Access Compliance Report Public Rights-of-Way (Curb Ramps)

Main Street: ANTONIO_PKWY Cross Street: WINDMILL_AVE Location: W

ADA ID: RPRK211029140722 Ramp Type: Type 1 - Perpendicular Diagonal Initial Pass/Fail: Fail Overall Compliance: No Severity Score: 2

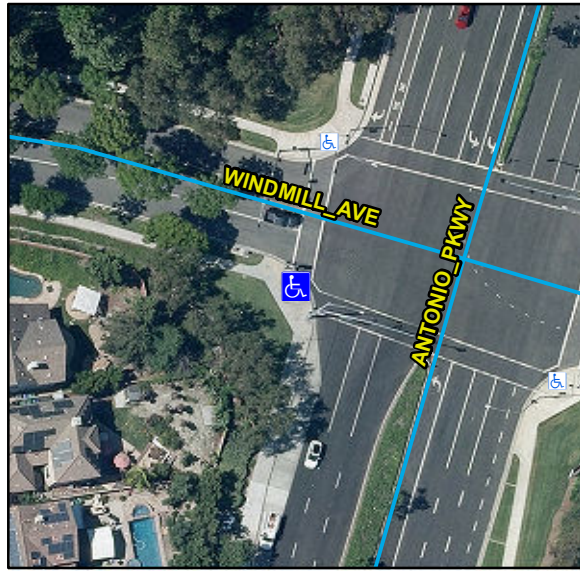
R304.2.2, R204.3, R304.5.3, STD 1115

Compliance	Description	Data	Compliance	Description	Data
N/A	Ramp Length (in)	103	N/A	Flare Type LT	
Yes	Ramp Width (in)	48			N/A
Yes	Ramp Run Slope (%)	0.9	N/A	Flare Slope LT (%)	N/A
No	Ramp Cross Slope (%)	3.7	N/A	Flare Traversable LT	N/A
N/A	Landing Present	N/A	N/A	Flare Type RT	
N/A	Landing Length (in)	N/A			N/A
N/A	Landing Width (in)	N/A	N/A	Flare Slope RT (%)	N/A
N/A	Landing Run Slope (%)	N/A	N/A	Flare Traversable RT	N/A
N/A	Landing Cross Slope (%)	N/A	N/A	DWS Provided	N/A
N/A	Landing Movement Obstructed?	N/A	N/A	DWS Contrast	N/A
	Landing Movement Type	N/A	N/A	DWS Length (in)	N/A
N/A	Landing Shared	N/A	N/A	DWS Full Width	N/A
N/A	Clear Space	Yes	N/A	DWS Offset Left (in)	N/A
N/A	Clear Space To Crosswalk (in)	48	N/A	DWS Offset Right (in)	N/A
N/A	Marked Crosswalk 1	Yes	N/A	Marked Crosswalk 2	Yes
	Crossing 1 Direction	SE		Crossing 2 Direction	NE
	Marked Crosswalk 1 Width (in)	110		Marked Crosswalk 2 Width (in)	110

N/A	Ramp Inside Crosswalk 1	Yes	Yes	Ramp Inside Crosswalk 2	Yes
	Crossing 1 Slope (%)	4		Crossing 2 Slope (%)	1.2
	Crossing 1 Cross Slope (%)	1		Crossing 2 Cross Slope (%)	2.1
N/A	Gutter Ponding	N/A	No	Curb Slope	7.3
Yes	Gutter Lip Height (in)	0		Road Run Slope (%)	2.3
N/A	Gutter Run Slope (%)	N/A		Road Cross Slope (%)	4.5
N/A	Gutter Cross Slope (%)	N/A			
Yes	Overall Surface Condition: Acceptable		No	Perp Joint Present	No
	Cross Gutter Present?	No		Spandrel Present?	No
	Replace Cross Gutter?	N/A		Replace Spandrel?	N/A

Remove & Replace Curb Ramp With Two New Directional Ramps or Equivalent.
